August 15, 2025

USD 321 Rossville High School Addition and CTE Renovation – JGR Proj #22-3269

ADDENDUM NO. 1

A2.0

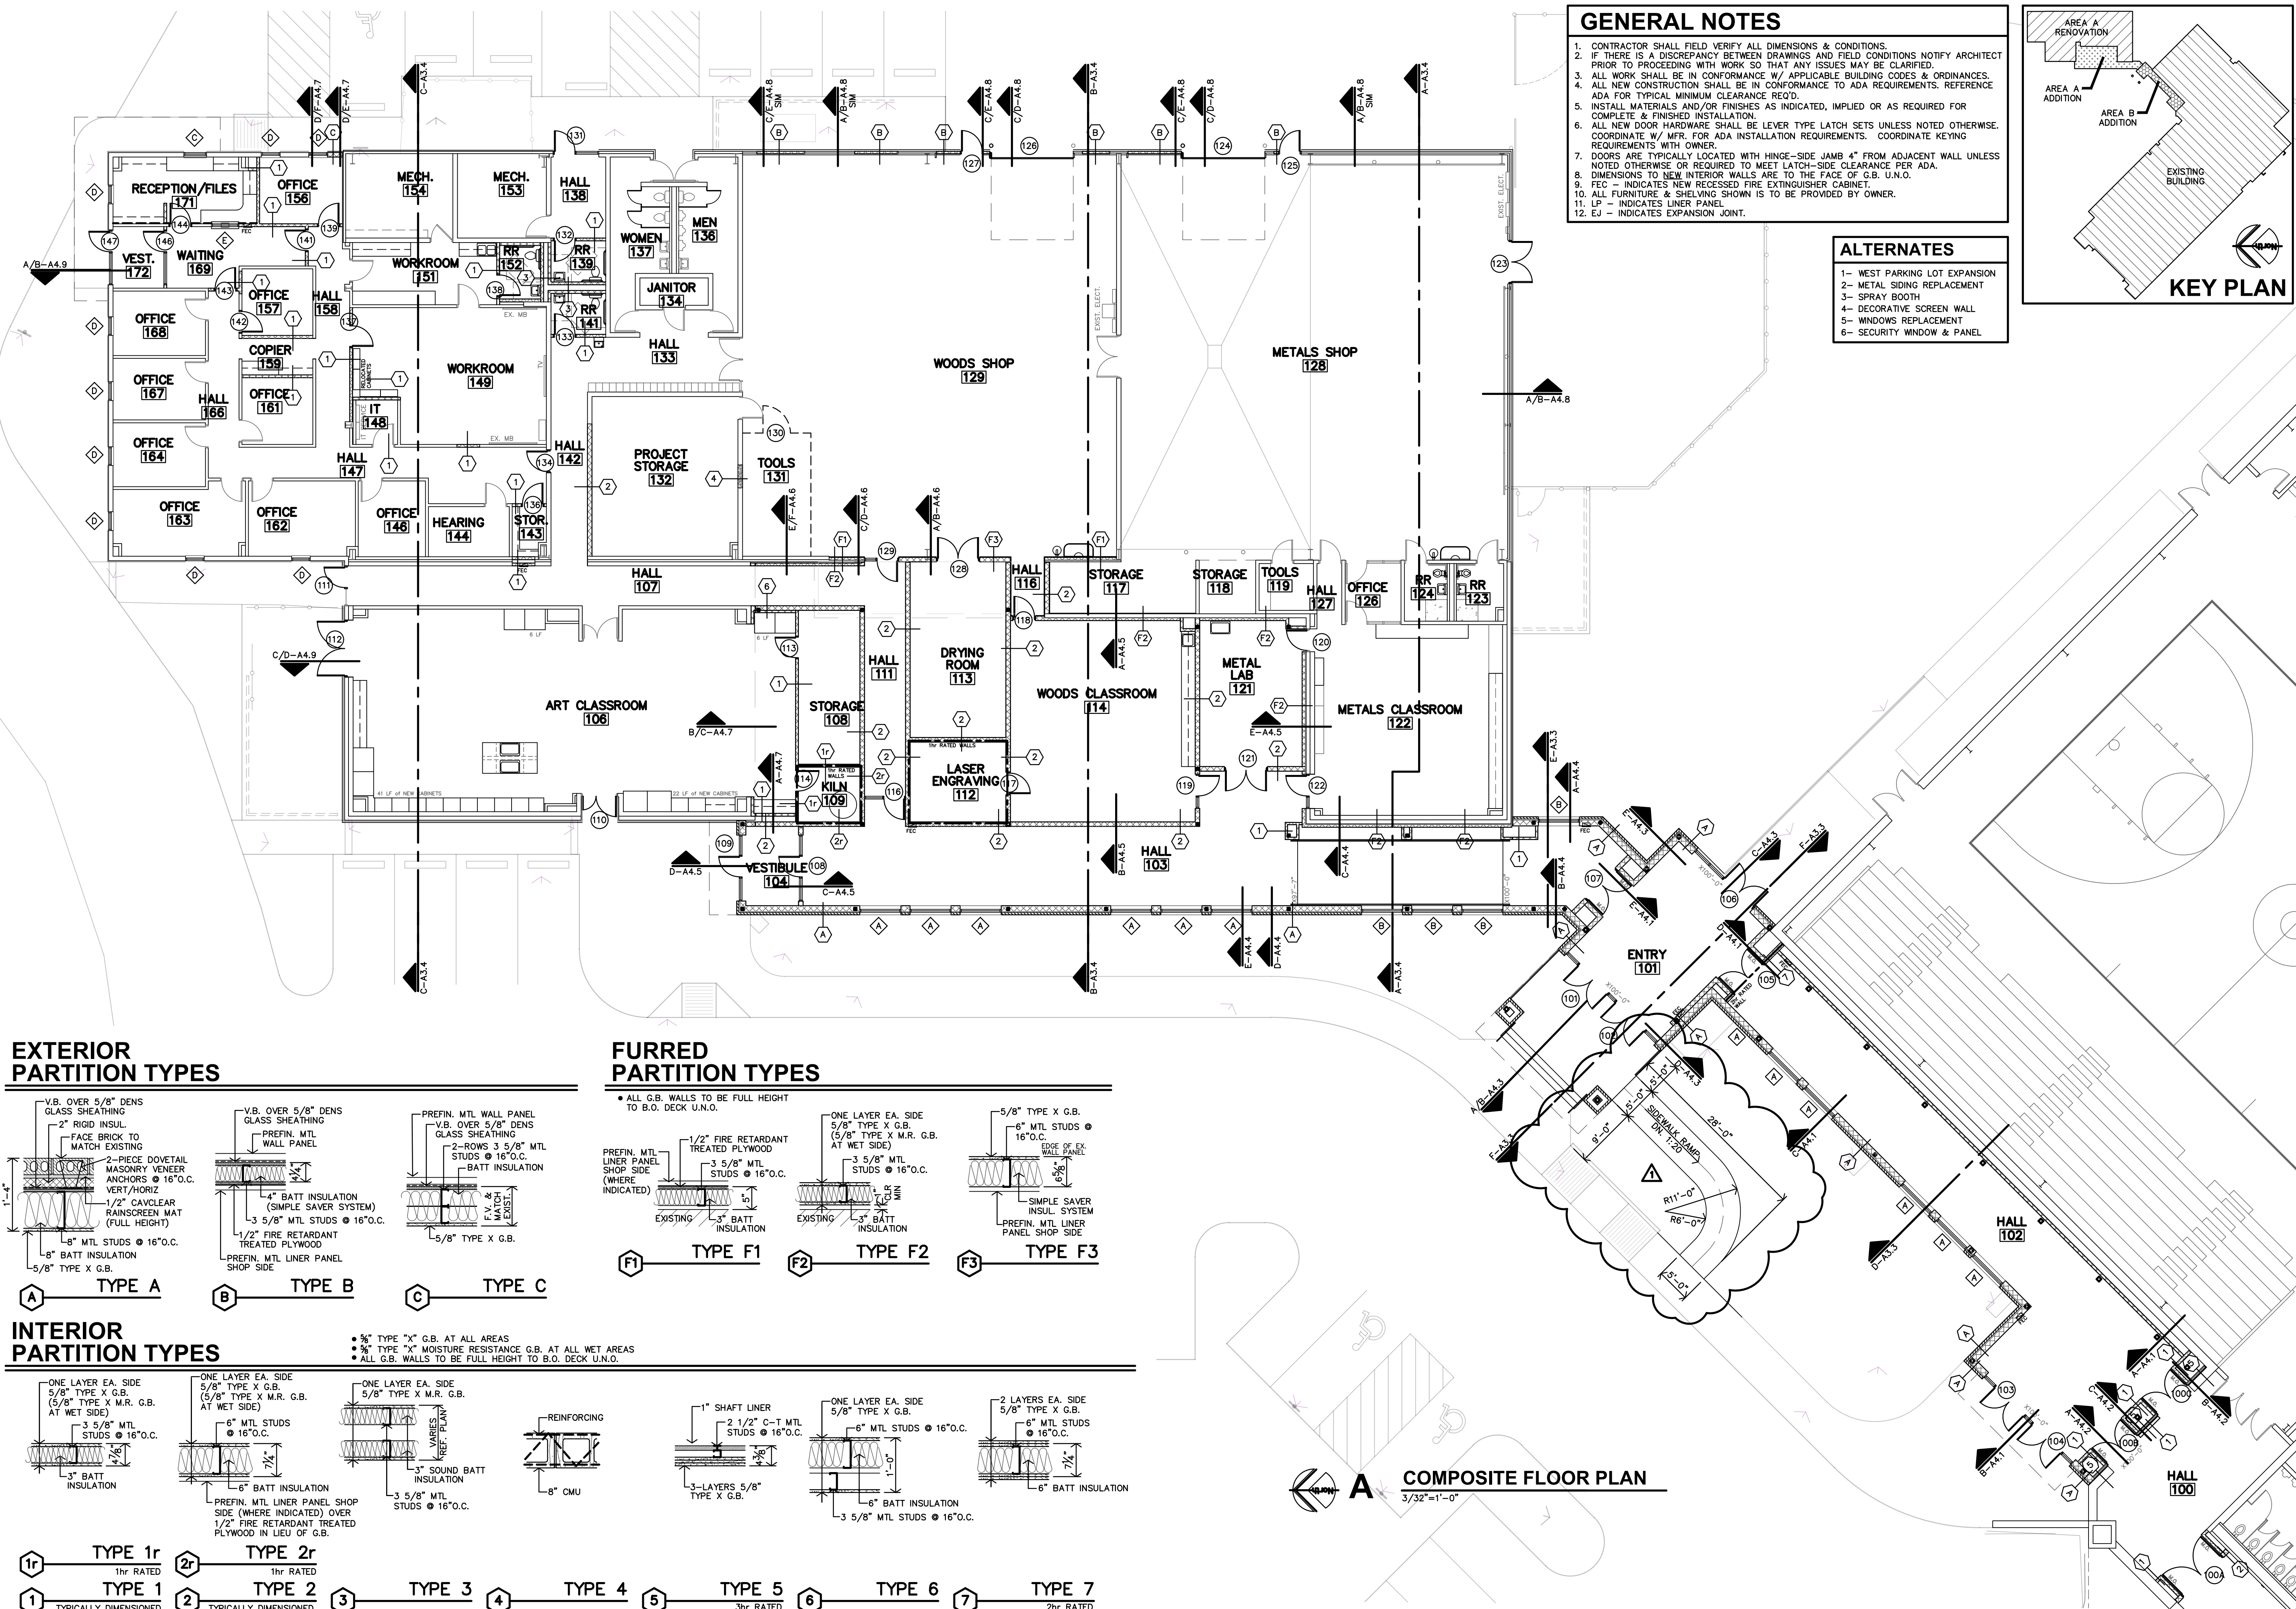
3. Sheet A1.0 and A2.0 Site and Floor Plans: A revised handicap sidewalk curb ramp, and handicap sidewalk to the center entrance is added. Reference the attached sheets A1.0 and A2.0.

A3.2

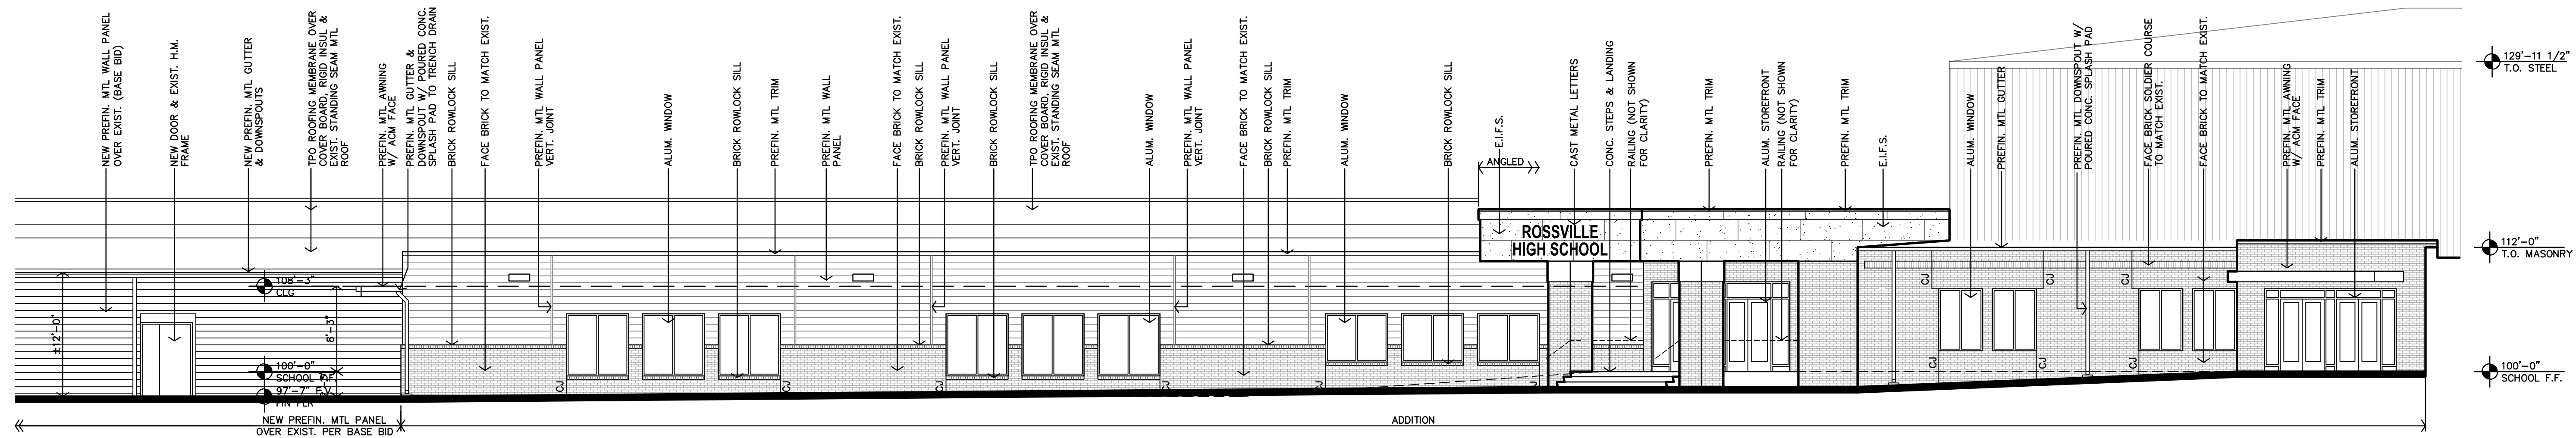
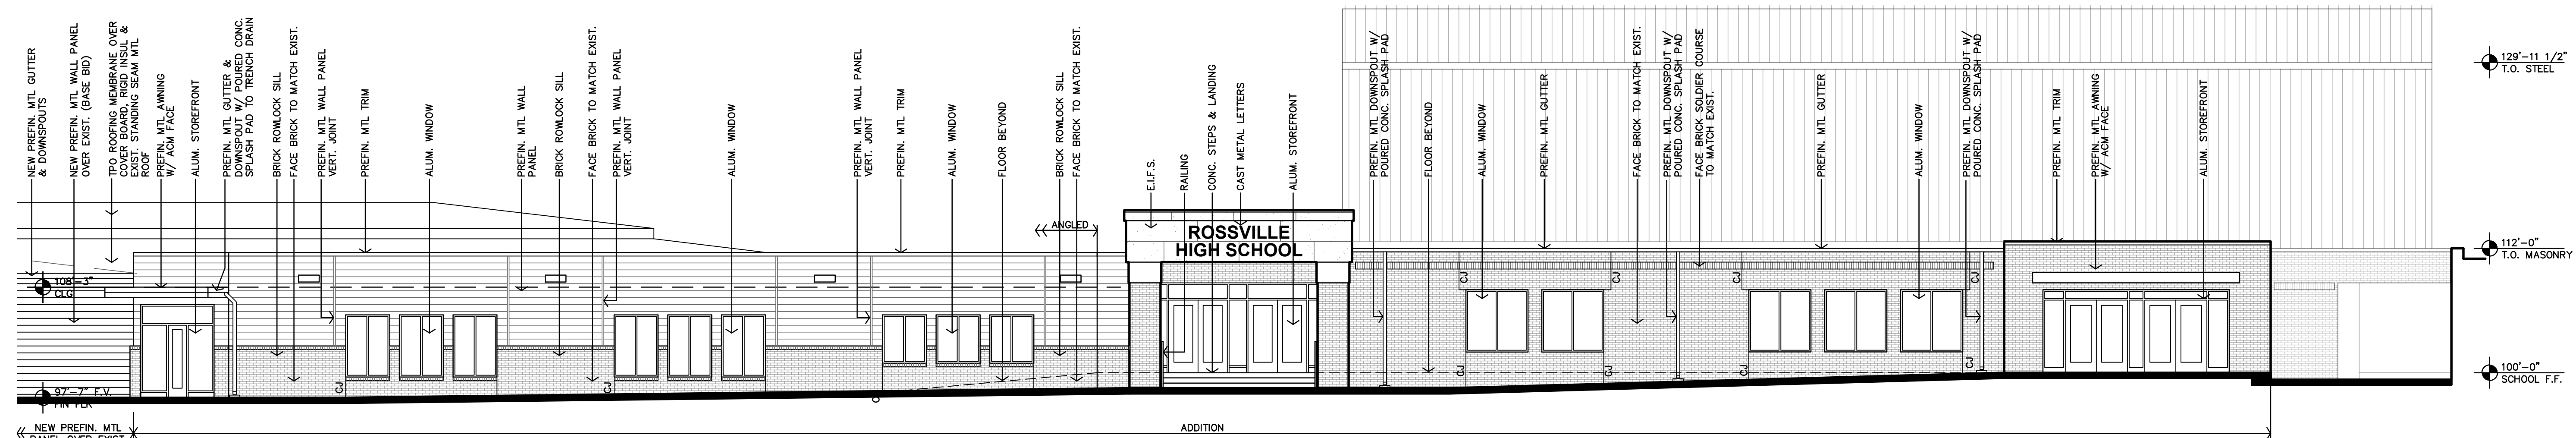
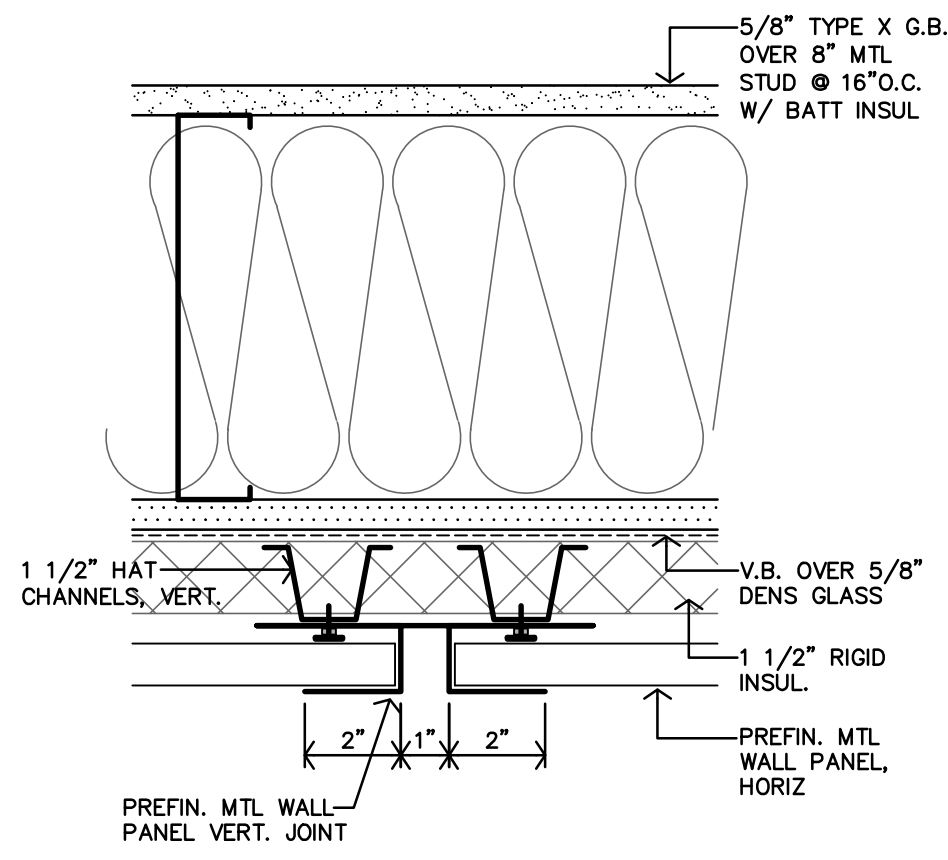
6. Sheet A3.2 and A3.3 Elevations: Clarification – At the existing CTE building, all eave and gable trim, and gutter and downspout shall be new and integrated with the new roofing. Disregard note identifying building trim as being per alternate 2.

A **ART CLASSROOM #106**
CASEWORK ELEVATION
3/8"=1'-0"

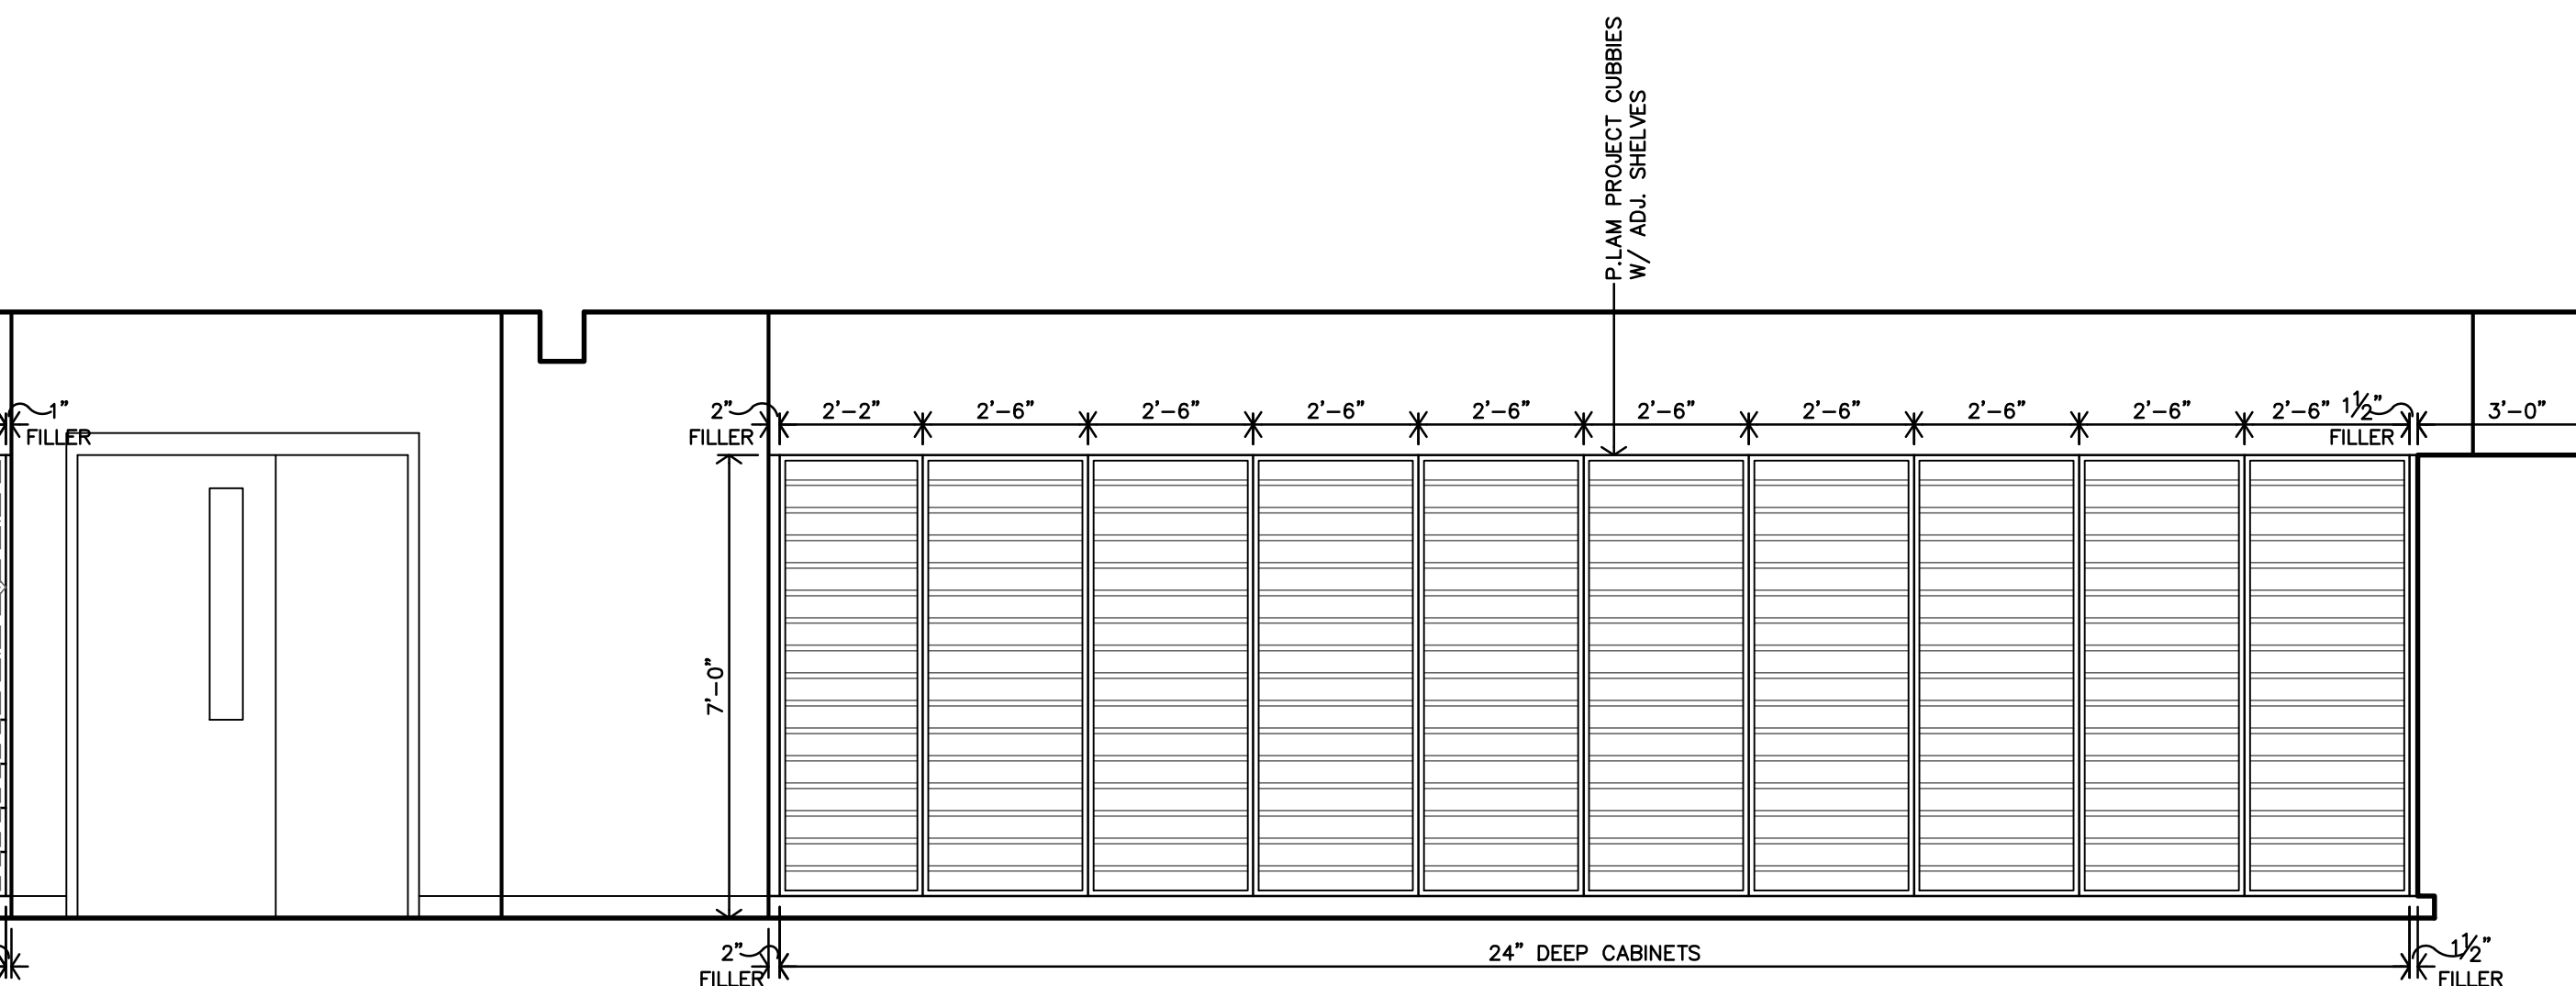
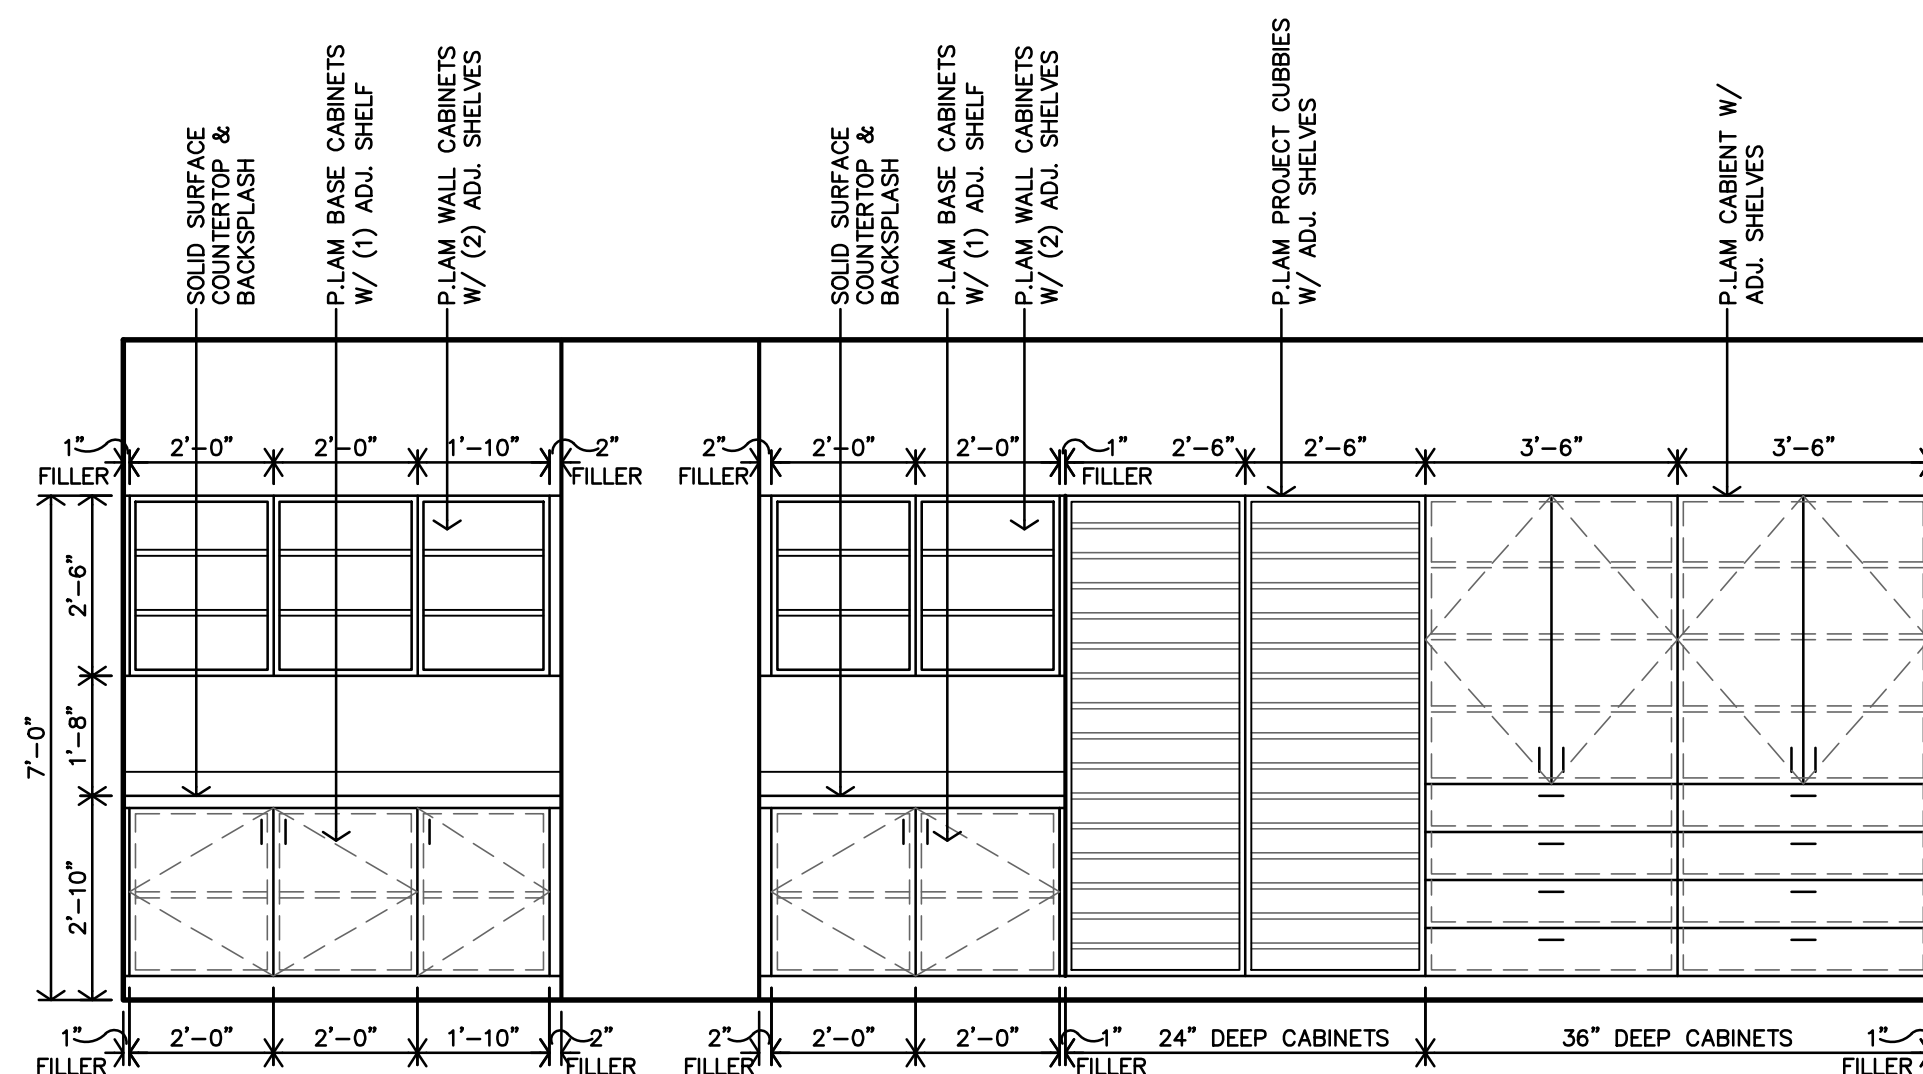
11. Sheet A9.4 Details D and E: Art classroom sinks shall be integral/welded with the stainless steel countertop. Sinks to be 18x24x12"d. Stainless steel counter requirements are stated in Sections 06410 Custom Casework, Paragraph 2.6.
